**TECHNICAL EVALUATION REPORT  
UMETCO MINERALS CORPORATION  
REQUEST FOR EXCLUSION OF CONSTITUENTS**

**DATE:** March 17, 2010

**LICENSEE:** Umetco Minerals Corporation

**FACILITY:** Gas Hills, Wyoming

**Figure 1. Groundwater monitoring wells at Gas Hills, Wyoming (Umetco, 2009c).**

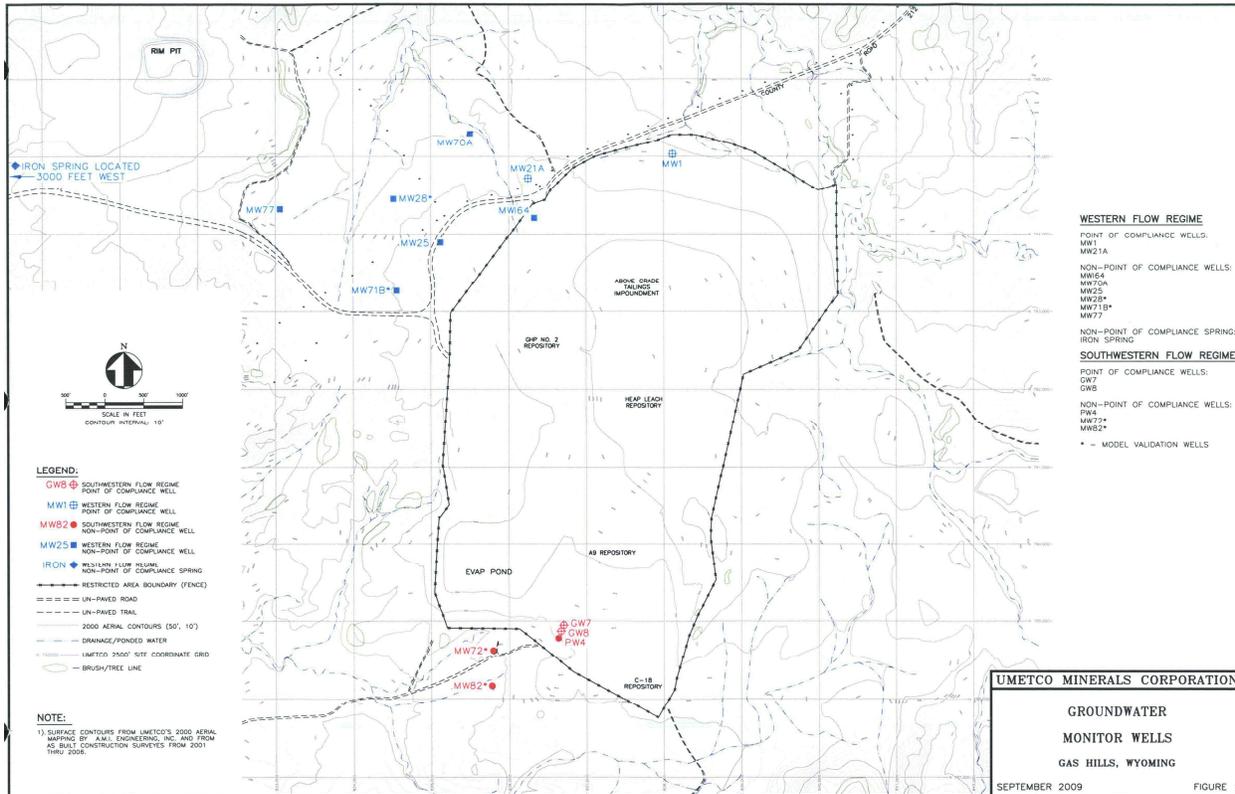
Under 10 CFR 40, Appendix A, Criterion 5B(2), cadmium may meet the requirement as a hazardous constituent as concentrations were above the MCL of 0.01 mg/L. The detected concentrations of cadmium were 0.0104 mg/L at POC well GW7 and 0.0101 mg/L at POC well GW8.

In a letter dated September 22, 2009, Umetco assessed the potential risks associated with cadmium based on a previously approved geochemical model, PHREEQC (NRC 2002, Umetco 2009, Umetco 2001). Independent analysis by NRC staff verified that retardation and attenuation are likely to result in cadmium concentrations well below the NRC approved background concentration of 0.01 mg/L (NRC, 1990) at the Point of Exposure for 1,000 years. In addition, using sampled concentrations from the tailings liquors and conservative parameters, NRC staff estimates that cadmium transport will not affect the Point of Exposure within 1,000 years [meeting 10 CFR 40, Appendix A, Criterion 5B(3)(a)(i), (ii), (vii), (ix)].

The Umetco Gas Hills site is located in an area that is expected to remain sparsely populated. The nearest down-gradient residence is located approximately 33 kilometers (20 miles) away. Natural mineralization and extensive mining operations in the vicinity of the site have resulted in ambient groundwater quality that is compatible with a WDEQ Class III designation that is suitable for livestock. Under provisions of the DOE's long term surveillance and maintenance requirements, installation of drinking water wells within the transfer area will be prohibited [meeting 10 CFR 40, Appendix A, Criterion 5B(3)(a)(iii), (iv), (v), (vi)].

Based on the NRC staff review of the September 22, 2009, and November 19, 2009, submittals, Umetco has demonstrated that groundwater concentrations of barium, cadmium, chromium, and lead at the Umetco Gas Hills site will not pose a substantial present or potential hazard to human health or the environment. NRC staff has determined that the previous exclusions for barium, chromium and lead are still applicable, and the exclusion from consideration of cadmium under 10 CFR 40, Appendix A, Criterion 5B(3) is acceptable. Therefore, no license amendment is required for this action.
